APPLICATION NO.	FILING DATE	FIRST NAMED INVENTOR	ATTORNEY DOCKET NO.	CONFIRMATION NO.
10/576,029	04/17/2006	Shigeo Kamamoto	4731-0132PUS1	8726
	7590 12/23/201 ART KOLASCH & BI	EXAMINER		
PO BOX 747	CH VA 22040 0747	IRVIN, THOMAS W		
FALLS CHURCH, VA 22040-0747			ART UNIT	PAPER NUMBER
			3657	
			NOTIFICATION DATE	DELIVERY MODE
			12/23/2010	ELECTRONIC

Application No.	Applicant(s)		
Office Action Commence	10/576,029	KAMAMOTO ET AL.		
Office Action Summary	Examiner	Art Unit		
	THOMAS IRVIN	3657		
The MAILING DATE of this communication app Period for Reply	ears on the cover sheet with the c	orrespondence address		
A SHORTENED STATUTORY PERIOD FOR REPLY WHICHEVER IS LONGER, FROM THE MAILING DA - Extensions of time may be available under the provisions of 37 CFR 1.13 after SIX (6) MONTHS from the mailing date of this communication. - If NO period for reply is specified above, the maximum statutory period w - Failure to reply within the set or extended period for reply will, by statute, Any reply received by the Office later than three months after the mailing earned patent term adjustment. See 37 CFR 1.704(b).	ATE OF THIS COMMUNICATION 36(a). In no event, however, may a reply be tim wi

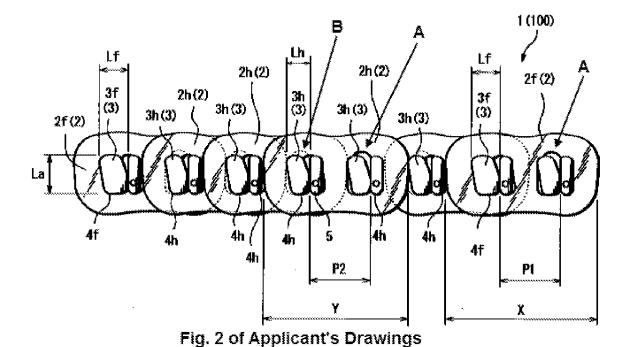
Referring to applicant's remarks filed 05 November 2010, applicant relies on fig. 2 for support for the amendments to claims 1, 2, and 6. The examiner however feels that fig. 2, shown above, appears to show that the links do not possess through-holes of the same shape. Specifically, the examiner points to the center-most link, identified as the short link (2h). Link (2h) is shown to possess two through-holes (4h), but of differing shape (A,B). The figure appears to show that the curved portion (A) of the through-hole is present on the right through-hole and not present on the left through-hole. The dotted lines are understood to indicate that the right through-hole of the link located behind the

center-most link contains a through-hole having this curved portion (B). The examiner further points to the right-most link, identified as (2f), which appears to also possess two differing through-holes (4f, 4h with the curved portion A).

Fig. 2, and the statements: that the right and left through-holes (4) in each link have mutually different configurations; and that the reference terms (4f) and (4h) are

merely used to identify the size of the through-hole and not the shape, appear to be in opposition to applicant's amendments. Therefore, the claims are rejected as containing subject matter which was not described in the specification in such a way as to reasonably convey to one skilled in the relevant art that the inventors, at the time the application was filed, had possession of the claimed invention.
